# VALUE ENGINEERING REPORT

Projects No. STP00-0002-00(409) and NH000-0006-02(056)

SR 300/SR 520 / US 82 Clark Avenue between Turner Field Road and  
SR 62 Cordele Road Improvements  
and  
SR 3 / Liberty Expressway @ Clark Avenue Ramps and Turn Lanes  
Improvements

November 16, 2010

ITEM N<sup>o</sup>: B-6  
CLIENT: GDOT  
Sheet 2 of 5

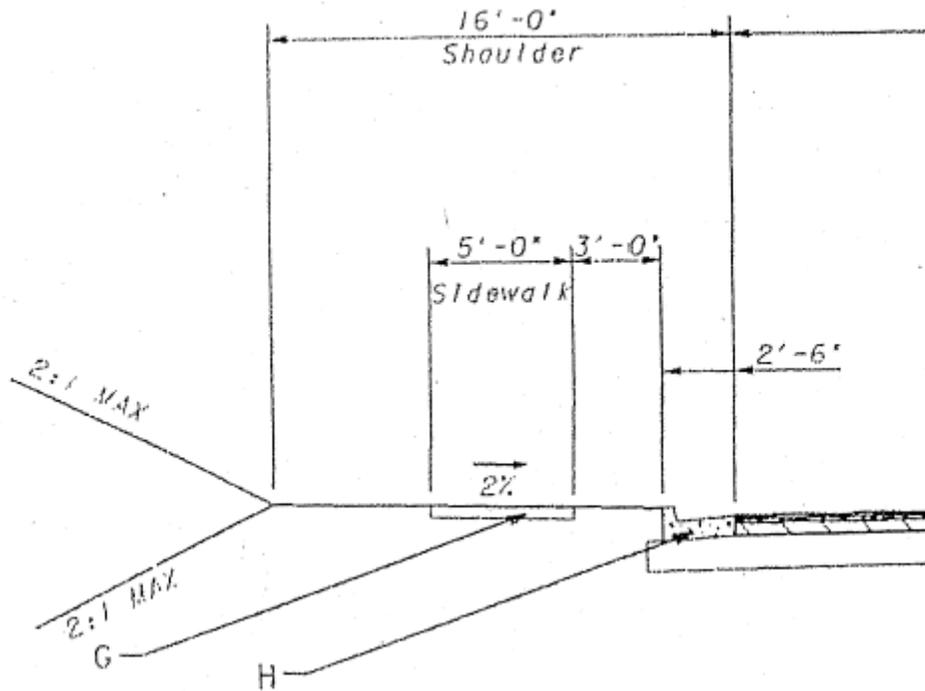
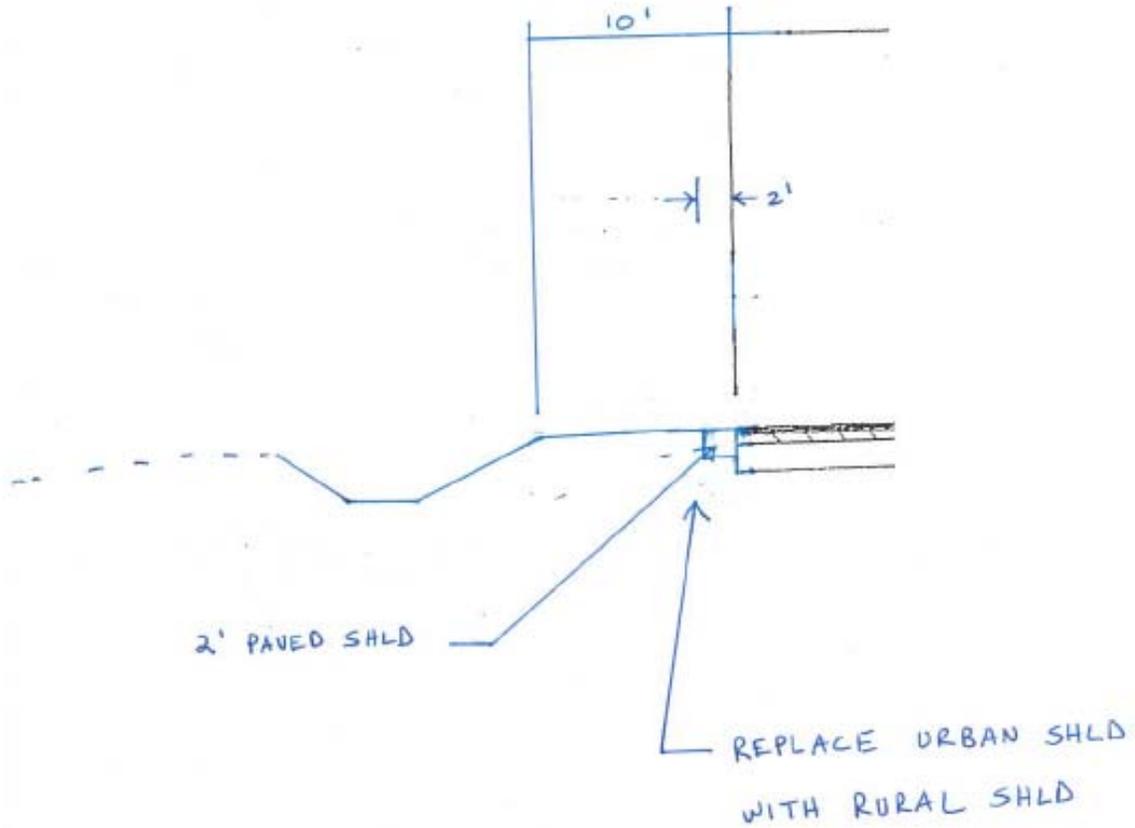
The revised concept proposes to implement a 10' rural shoulder (2' paved/ 8' grass) from Clark Avenue Sta 28+00 to 93+00. No sidewalk is proposed in this area.

The north side of Clark Avenue is undeveloped from Sta 28+00 to 93+00 and no sidewalk is necessary to connect existing commercial or residential properties. The longitudinal drainage system present along the north side of Clark Avenue can be replaced by the installation of a ditch with adequate capacity. Significant cost savings in curb and gutter, storm drainage, and sidewalk will result from implementing the revised concept.

Item No. D-2  
Sheet 3 of 6

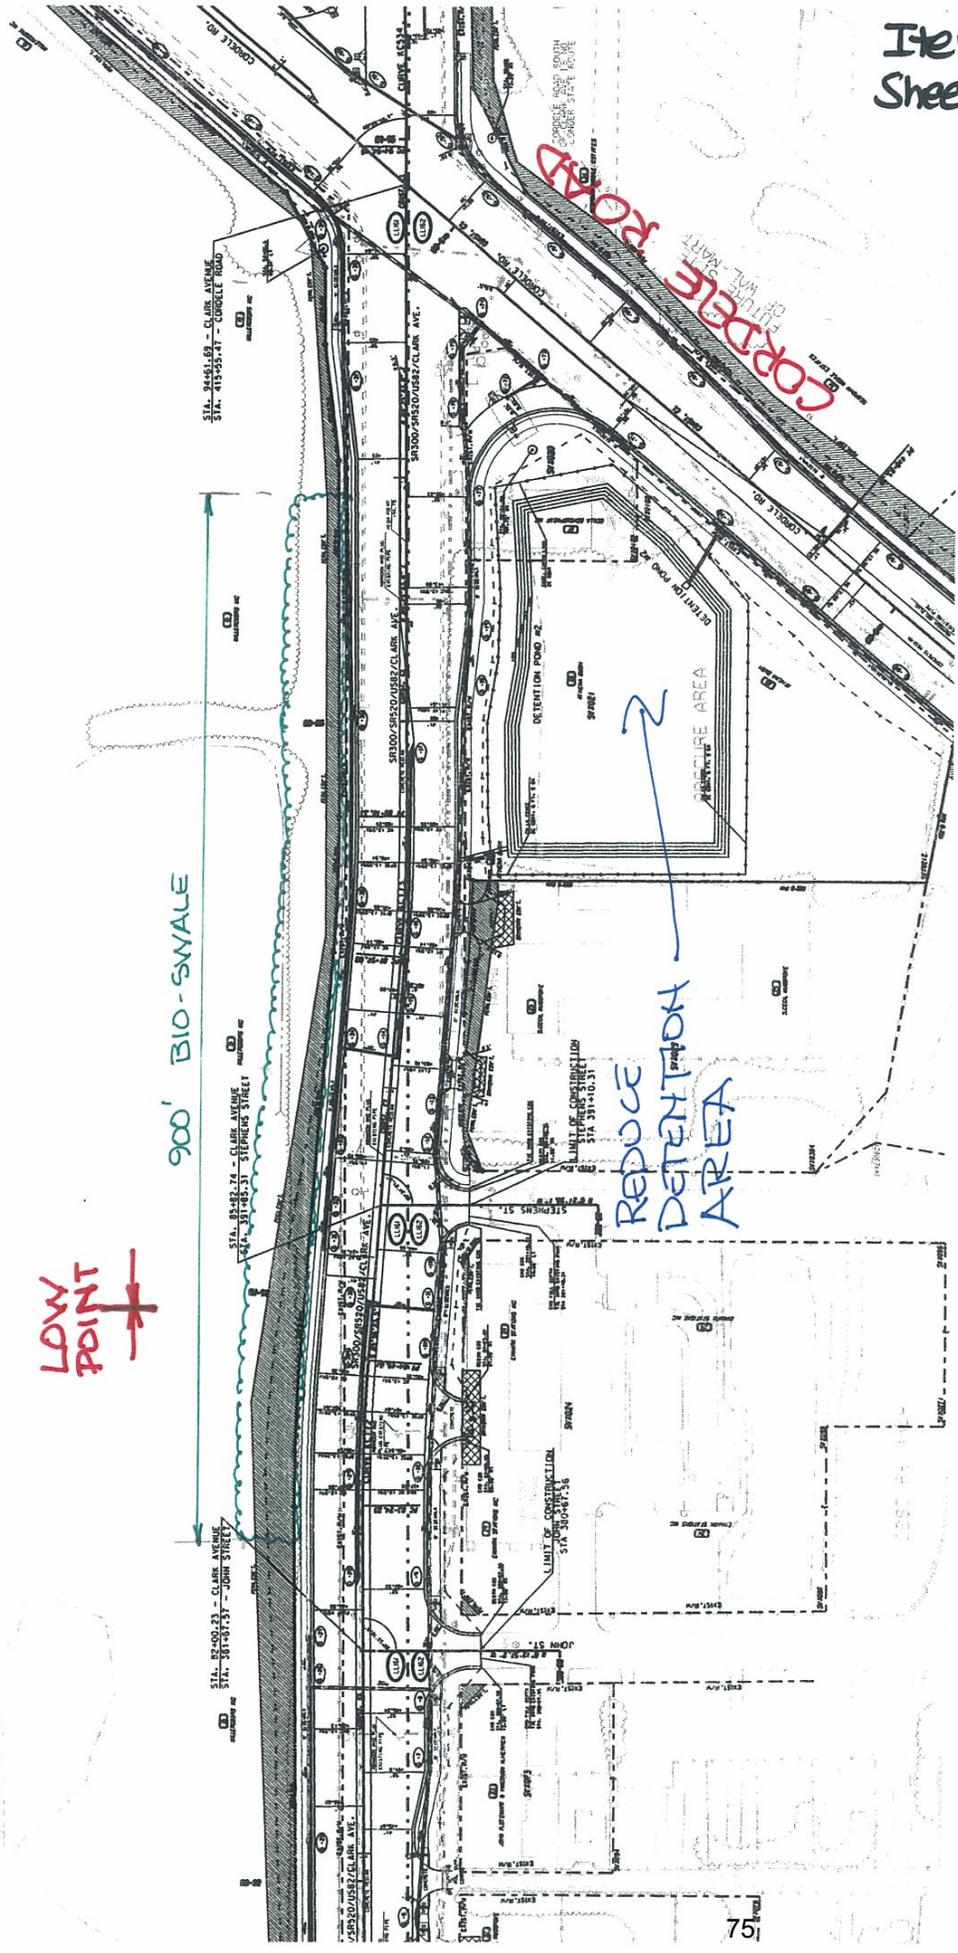
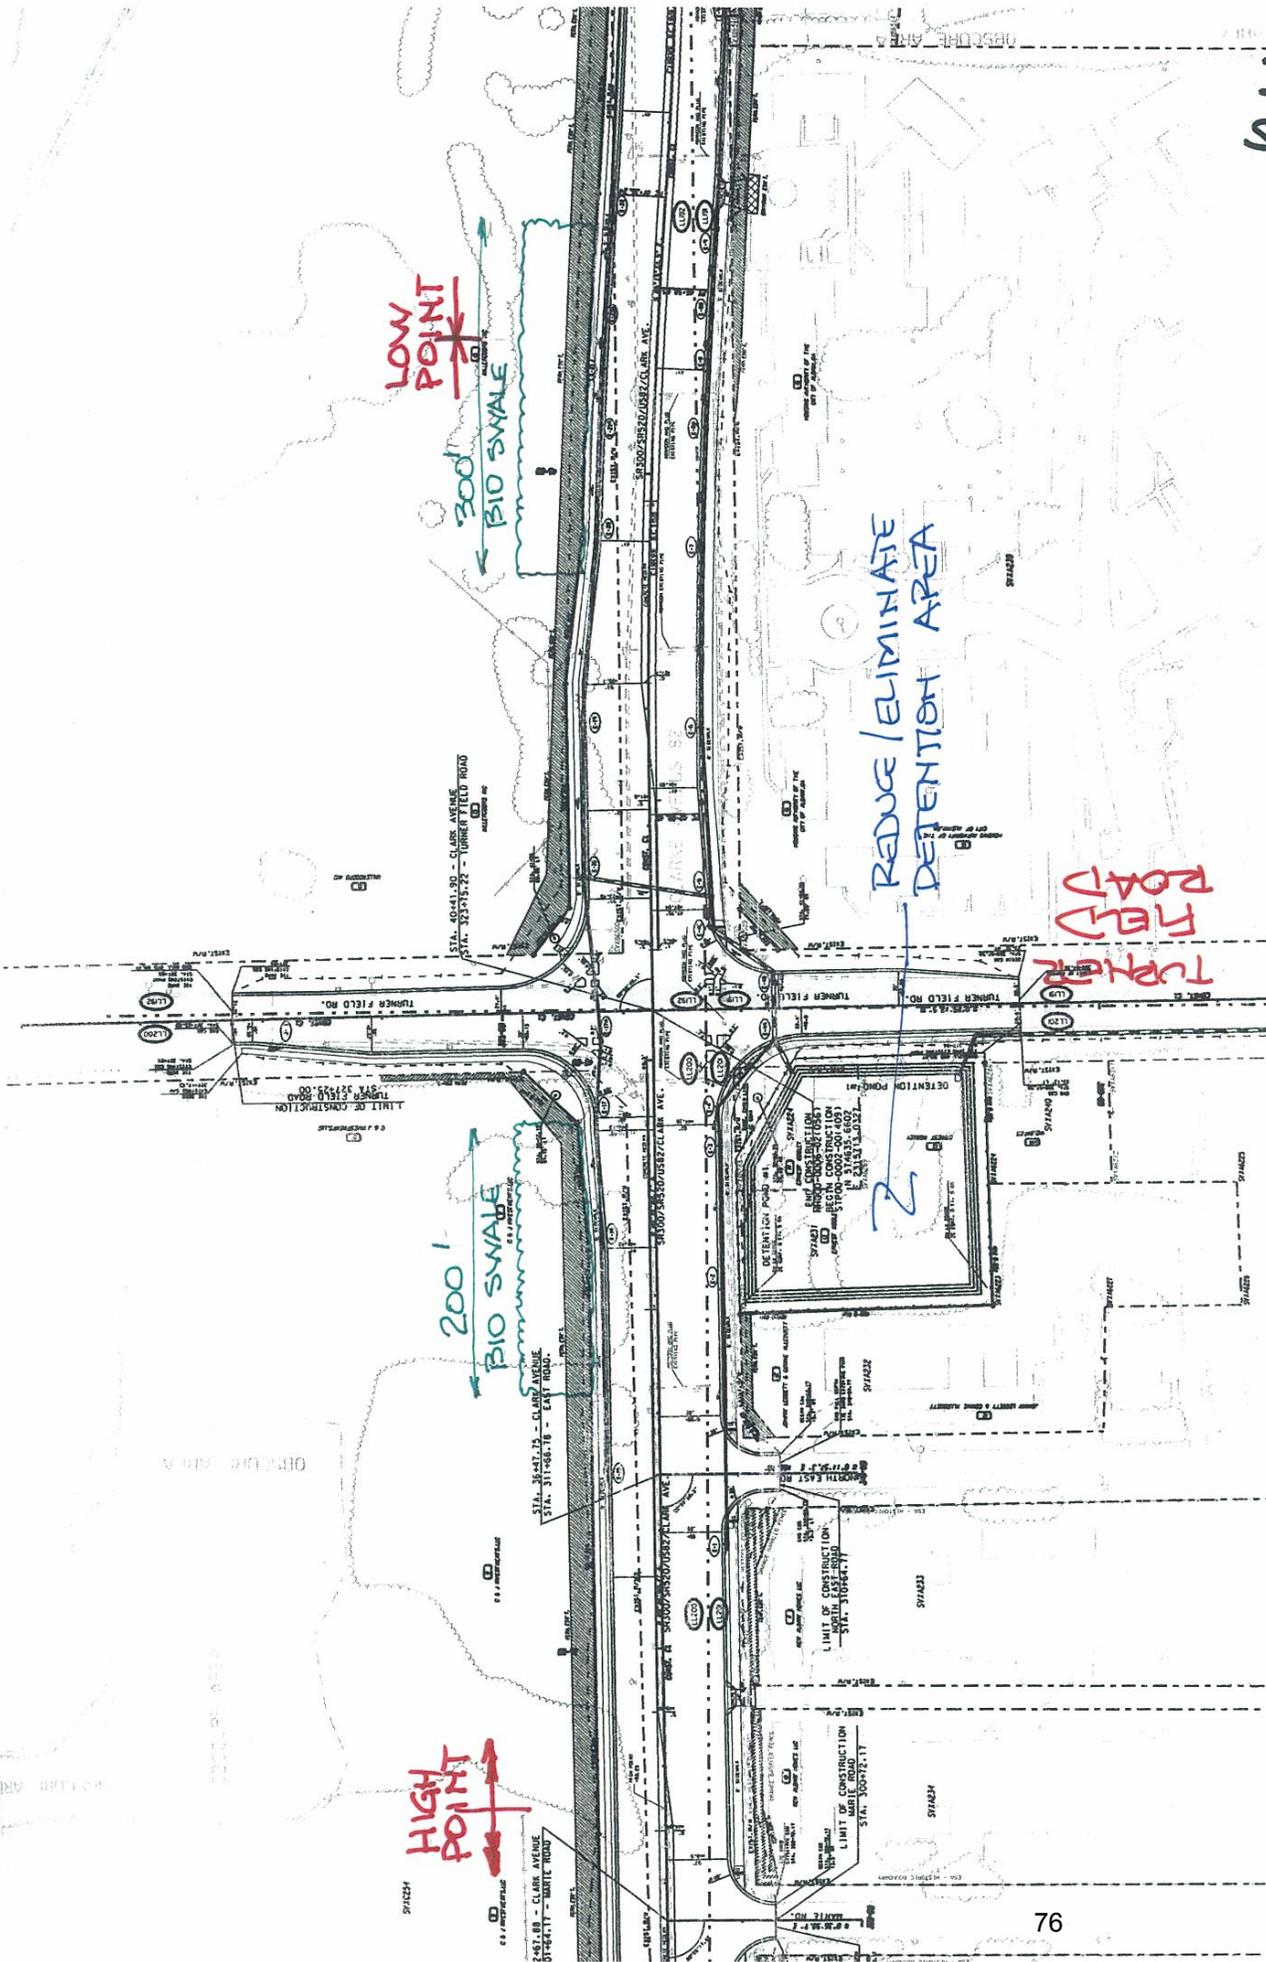
Review the drainage design to minimize and/or eliminate the detention areas using oversized roadside ditches that can also be developed into bioswales.

Eliminating detention areas will reduce long term maintenance and security concerns for fenced-in conventional detention ponds. GDOT does not typically provide detention facilities. This recommendation will require a detailed review of the drainage design and hydrology. The current layout provides for all the run-off to be collected and piped to the detention areas, while this recommendation proposes to provide smaller areas, roadside ditches, and bioswales to reduce maintenance and security issues. The location of the proposed swales is on the northern side of the roadway that is currently undeveloped. Incorporating roadside ditches could also eliminate the need for the longitudinal piping system, and swales can be used in lieu of catch basins. The areas for ditches vs. detention are generally similar; however, additional right-of-way or easements could be required. They will be within the MillerCoors property, which should all be negotiated comprehensively. This solution is somewhat more environmentally friendly and could be viewed as an amenity by the property owner.

<b>IDEA No.:</b>	<b>PAGE No.:</b>	<b>CREATIVE IDEA:</b>	
D-4	1 of 4	Use modified rural section in select area	
Comp By: GAO	Date: 11/3/10	Checked By: DCW	Date: 11/3/10

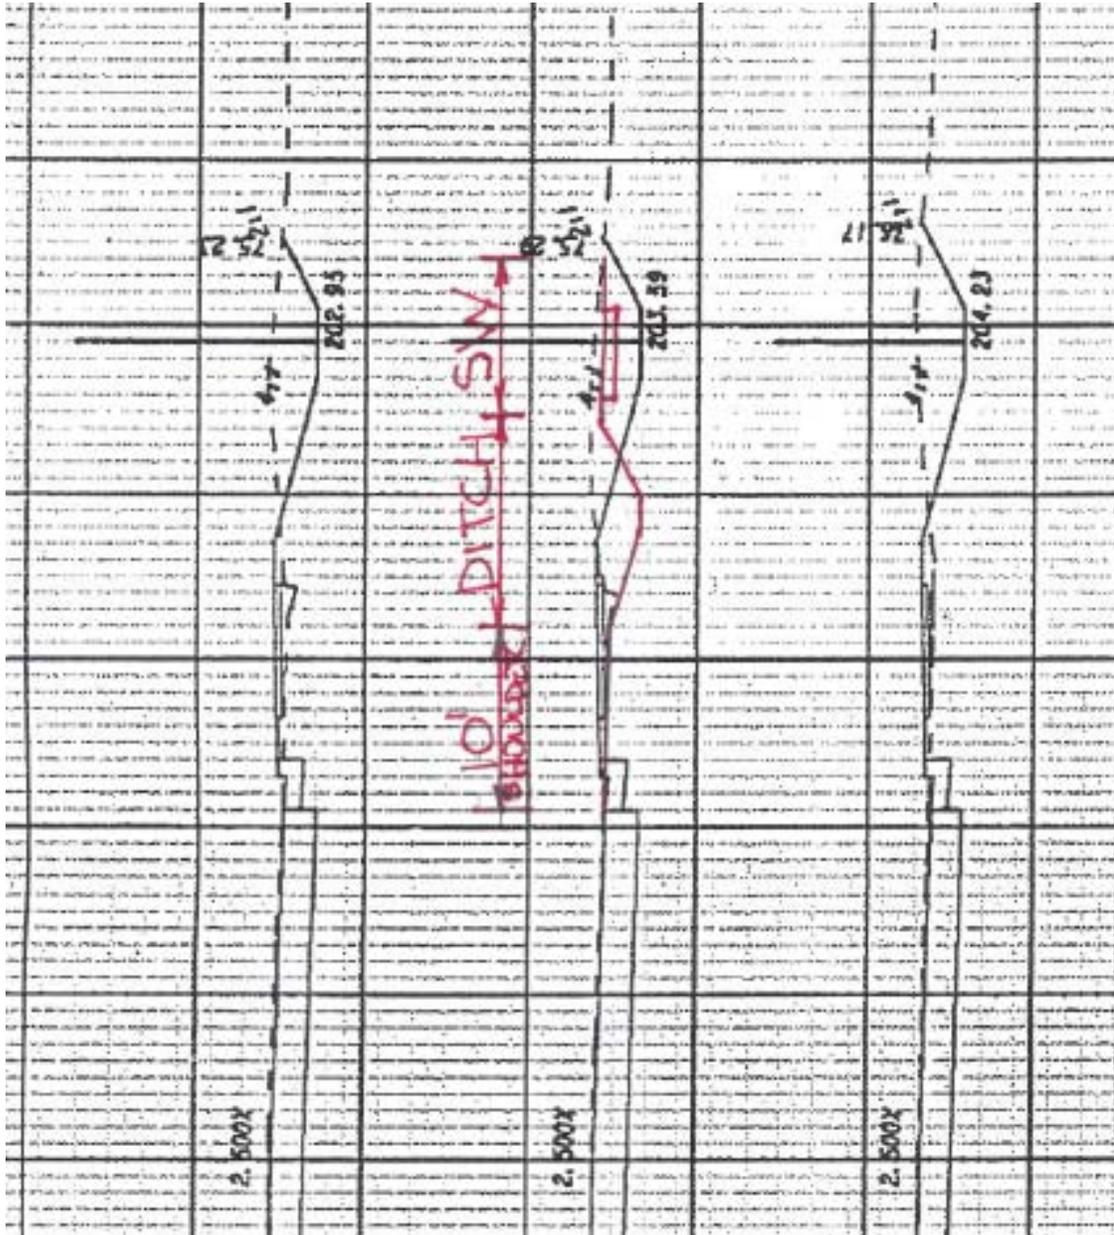
In the area from School Street to North Mock Road, revise the typical section to a modified rural section, eliminating the curb and gutter and closed drainage system. Keep the open ditch and move the sidewalk to the outside of the typical section.

With the proposed typical section, there is redundancy in providing both a closed and open drainage system. This recommendation would eliminate the closed drainage system and maintain the open system. It is in the area of the trailer park where most of the trailers are either abandoned or being purchased as an easement. The sidewalk will be moved to the outside of the typical section, further from the travelled way. The area is shown as permanent easement which would have to be converted to right-of-way, similar costs.

<b>IDEA No.:</b>	<b>PAGE No.:</b>	<b>CREATIVE IDEA:</b>
G-4	1 of 3	Use alternate detail for under-bridge pier protection
Comp By: GAO		Date: 11/3/10
		Checked By: DCW
		Date: 11/3/10

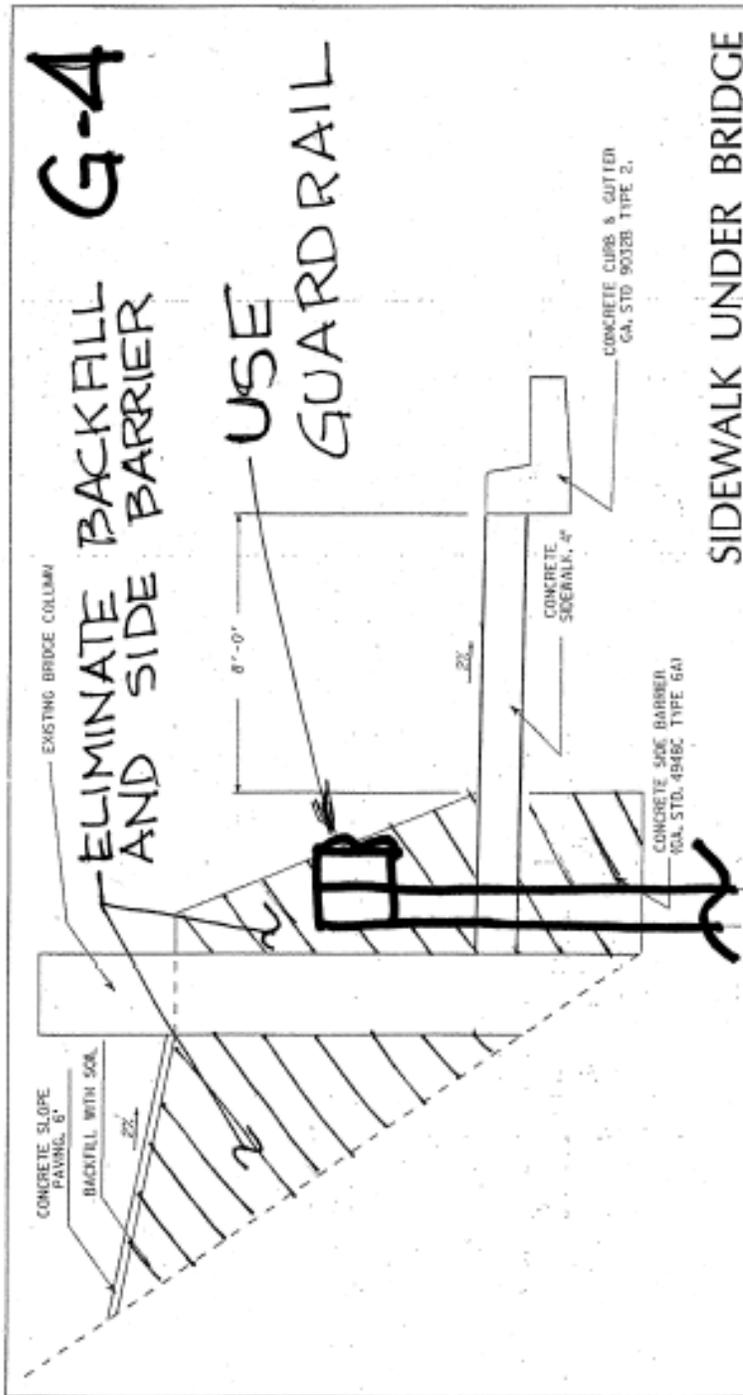
Consider using an alternate design of guardrail. This could also address any drainage or ponding concerns under the bridge.

The detail as proposed could have some constructability issues with compaction of fill against the existing piers and interface between the existing slope paving and new construction. An alternate design could be considered. GDOT Standard 4948 shows the concrete side barrier against the bridge piers but this detail is more suited to areas without curbing and sidewalk. Installing guard rail along the edge of the sidewalk could be considered. Also, the sidewalk width could be reduced to allow a greater separation between the guardrail and the columns.
